SUBJECT: Forwards info requested on 960401 re 960401 proposed amend  
to TS Section 3/4.9.6, "Refueling Machine."

Subject: Palo Verde Nuclear Generating Station (PVNGS)  
Unit 2  
Docket No. STN 50-529  
Supplement to Proposed Amendment to  
Technical Specification (TS) Section 3/4.9.6,  
"Refueling Machine," Under Emergency Circumstances

**NRC QUESTIONS AND APS RESPONSES RELATED TO  
PROPOSED AMENDMENT TO TECHNICAL SPECIFICATION  
SECTION 3/4.9.6 "REFUELING MACHINE"  
UNDER EMERGENCY CIRCUMSTANCES**

CONCEPTUAL  
 FUEL BUNDLE STRAP ASSEMBLY  
 STRAP SCHEME  
 QUESTION 1      FIGURE 1

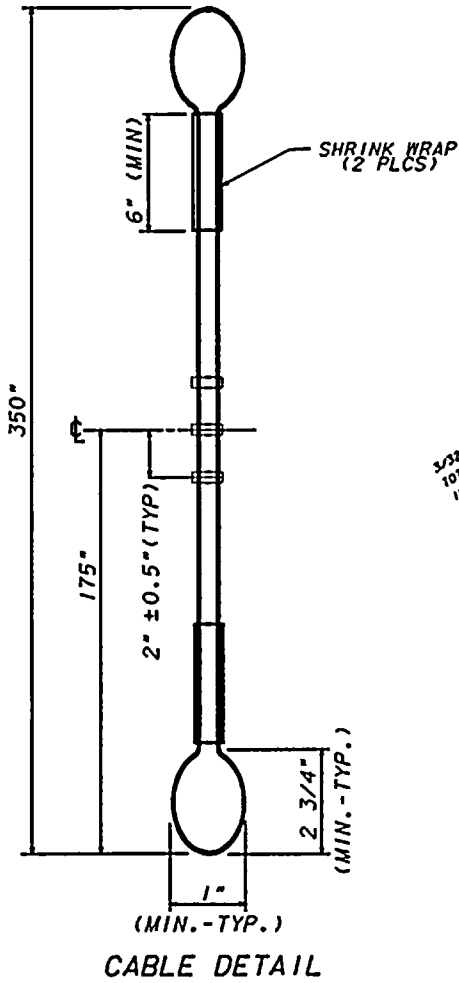
1. How will the structural integrity of the fuel assembly at location A-07 be assured during movement?

Structural integrity of the fuel assembly will be assured by installing external reinforcement using one of the following two methods:

The first method of reinforcement is the use of two separate 1 inch wide stainless steel straps installed on opposite sides of the assembly. The straps will be attached by clips to a steel jacking plate, installed on the upper plate at the top of the assembly, and to the web of the assembly's lower end fitting (LEF) (See Figure 1). The jacking plate will have adjusting bolts that would press against another steel plate underneath (the bearing plate) and thus pull up on, and tension, the straps. The straps will be tensioned enough to take up the slack, but not enough to compress the fuel assembly.

CONCEPTUAL  
 TEMPORARY LIFT RIG  
 REF: QUESTION #2  
 FIGURE 3

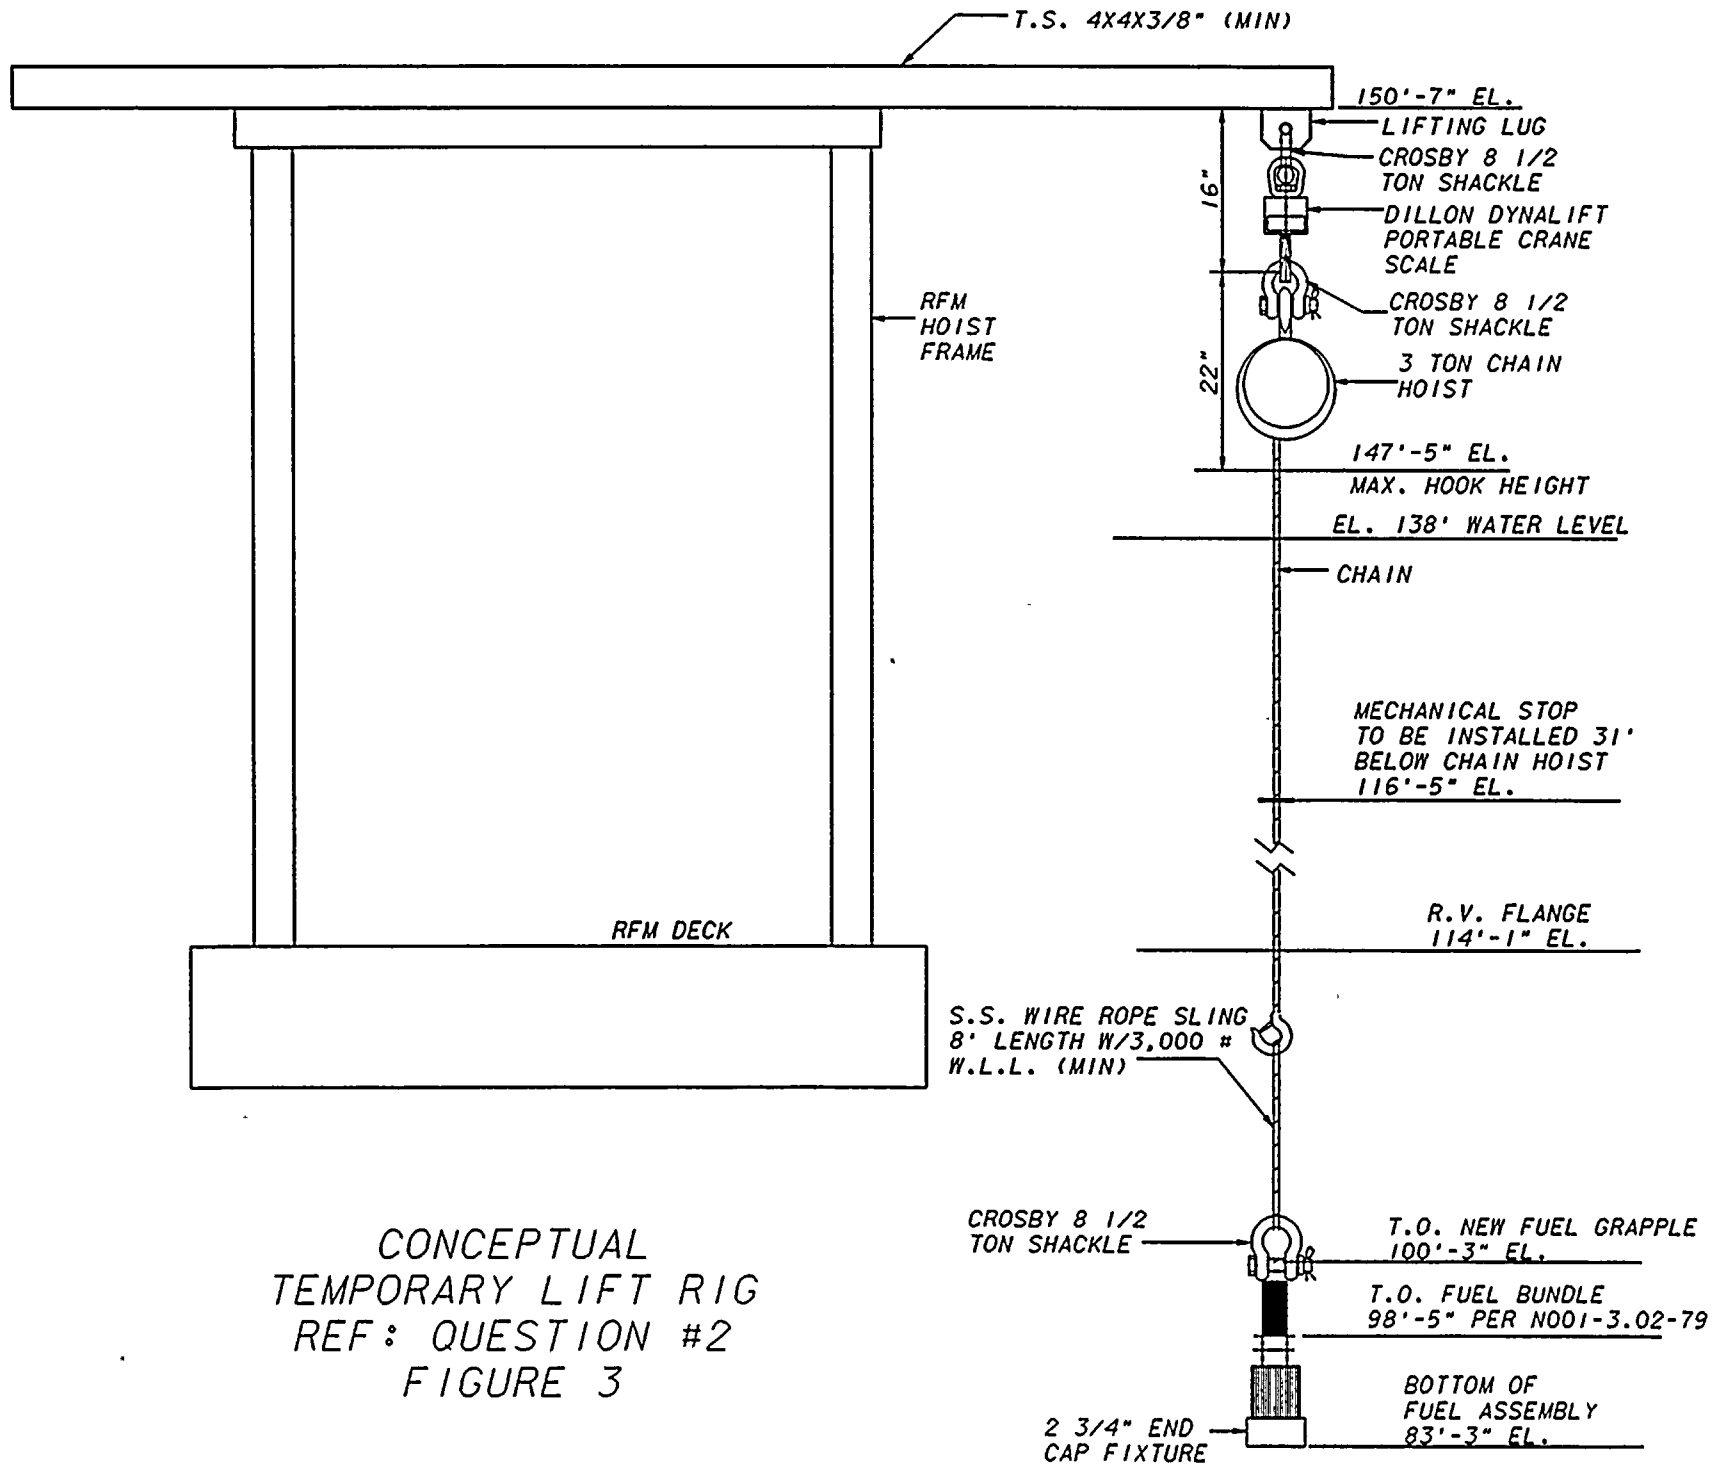
**2. Describe how the temporary hoist will be attached to the refueling machine.**

- An 8 foot, 4 inch long, 4 inch square steel tube will run across the top of the refueling bridge hoist frame rails. The tube will be attached to the hoist frame rails by two 1/2 inch U-bolts and a 3/4 inch steel plate at each rail. The beam will extend 41 inches

past one side of the refueling machine frame rail. A lug will be welded to the underside of the beam such that the load cell/hoist assembly will hang at a position 36 inches past the frame rail. The beam has a design capacity of at least 3000 pounds, which is approximately 1.5 times the maximum expected load.

- A load cell (with a capacity of 5000 pounds) will be hung from the lug, welded to the underside of the beam at the end, extending past the refueling machine.
- A hoist will be hung from the load cell.
- The new-fuel grapple hung from the hoist.

A drawing is attached that shows the temporary lift rig attachment (See Figure 3).
